**CASE NO. A-6661**

**PETITION OF CONGRESSIONAL MARYLAND HOMES, LLC**

Re: **COMBINED STORMWATER MANAGEMENT  
CONCEPT/SITE DEVELOPMENT  
STORMWATER MANAGEMENT PLAN** for  
8516 Meadowlark Lane  
Preliminary Plan #: 620210030  
SM File #: 286353  
Tract Size/Zone: 0.887 Acres R-90  
Total Concept Area: 0.887 Acres  
Lots/Block: Lots A&B Block Q Section 2  
Parcel(s): N/A  
Watershed: Cabin John Creek

RE: Administrative Plan No. 620210030  
8516 Meadowlark Lane

SHEET TITLE:  
Administrative  
Subdivision Plan  
Fire Dept. Access Plan

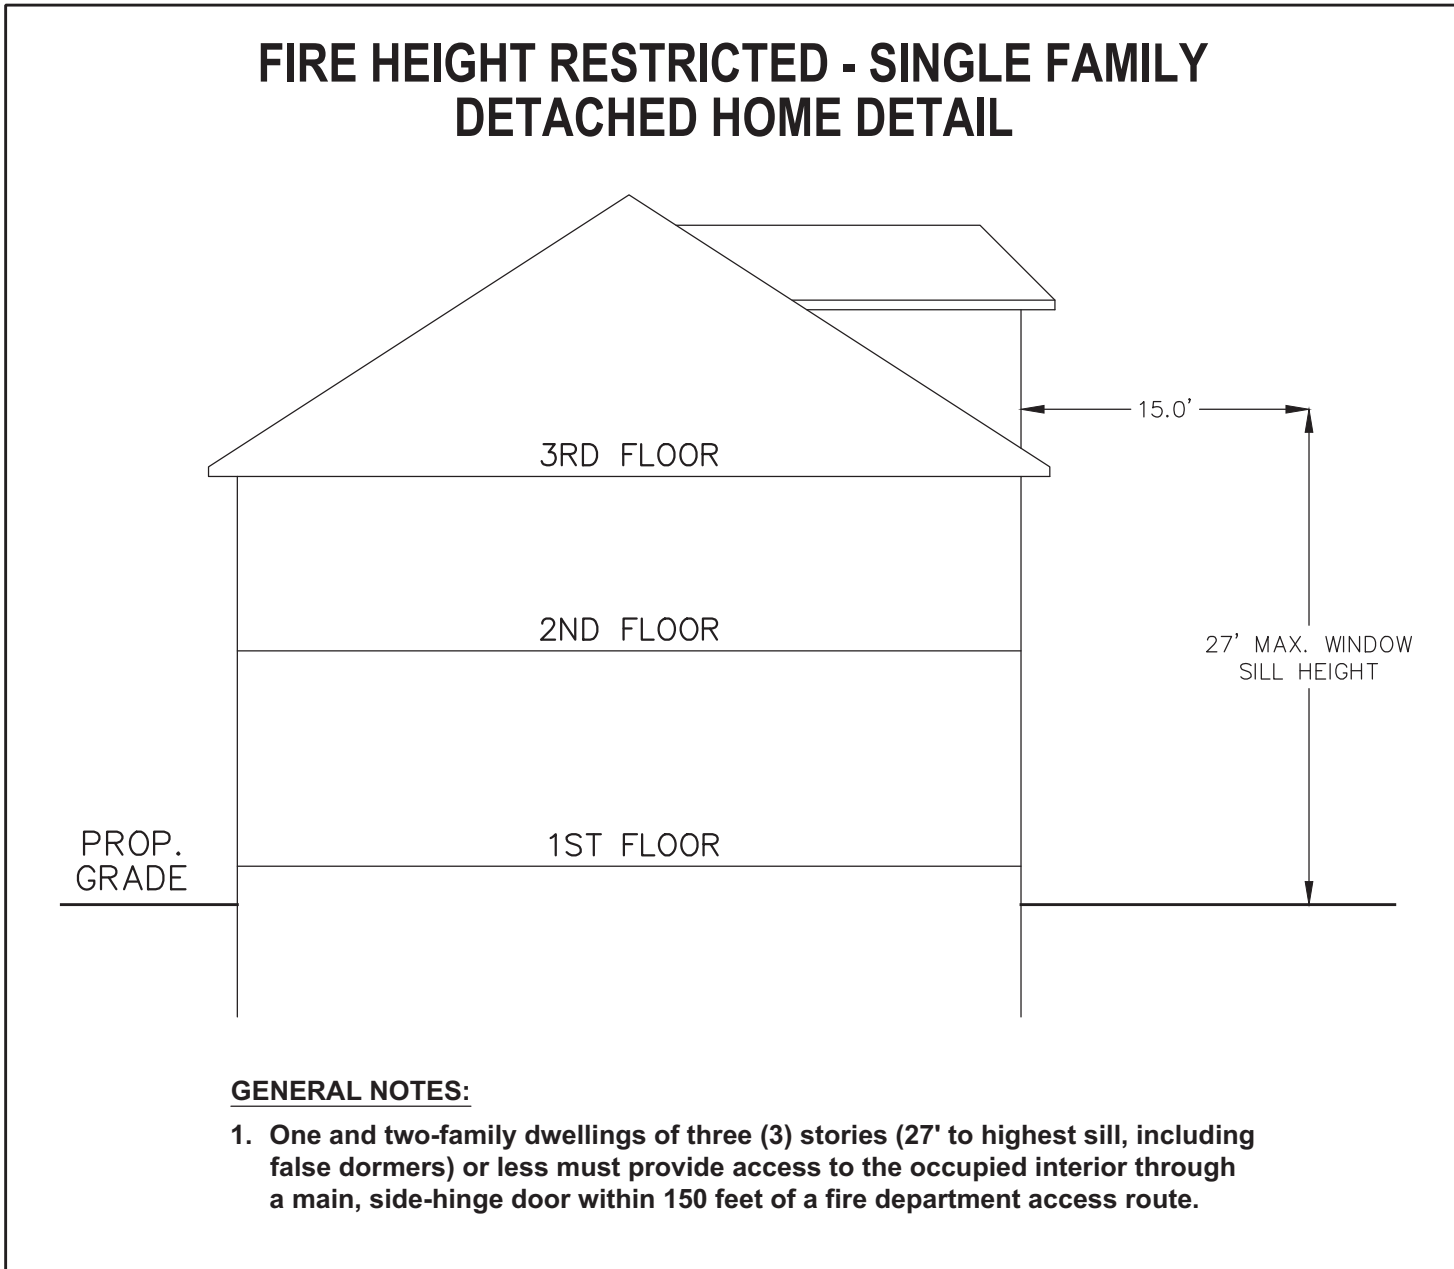
1. Review based only upon information contained on the plan submitted **10-Nov-20**. Review and approval does not cover unsatisfactory installation resulting from errors, omissions, or failure to clearly indicate conditions on this plan.
2. Correction of unsatisfactory installation will be required upon inspection and service of notice of violation to a party responsible for the property.
